CITY OF ALBUQUERQUE

RE: 1212 Riverview Dr NW
Grading and Drainage Plan
Engineer's Stamp Date: 12/31/23
Hydrology File: J11D047

Based upon the information provided in your submittal received 01/02/2024, the Grading & Drainage Plan is approved for Grading Permit (earthwork can get started for the earth pad on the house and retaining walls).

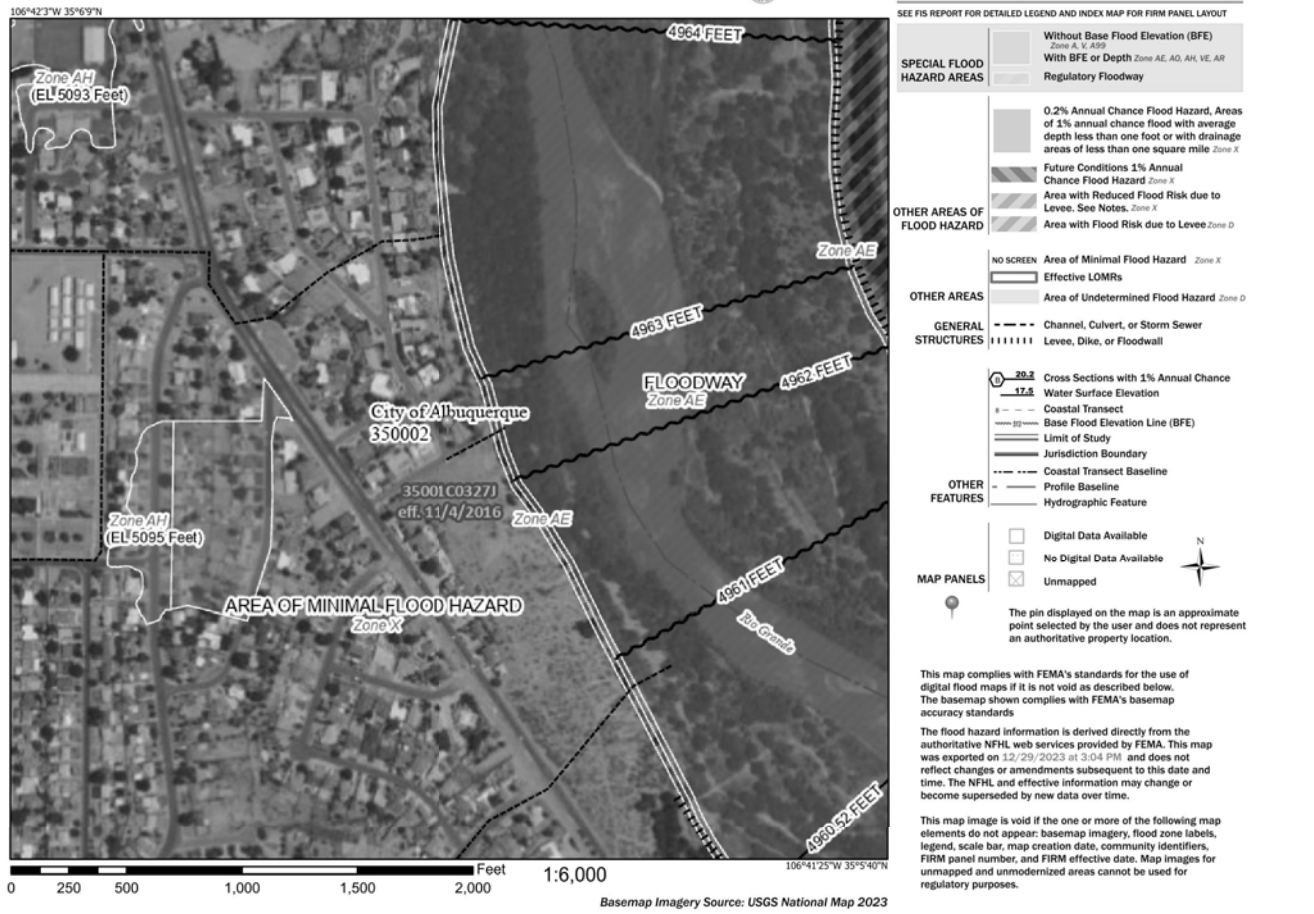
1. Once the grading is complete, a pad certification (meaning that the earthwork and retaining walls are complete) will be required. Please include a site photo with the submittal. Also, at the time of pad certification approval, Hydrology will concurrently approve the Grading & Drainage Plan for Building Permit.
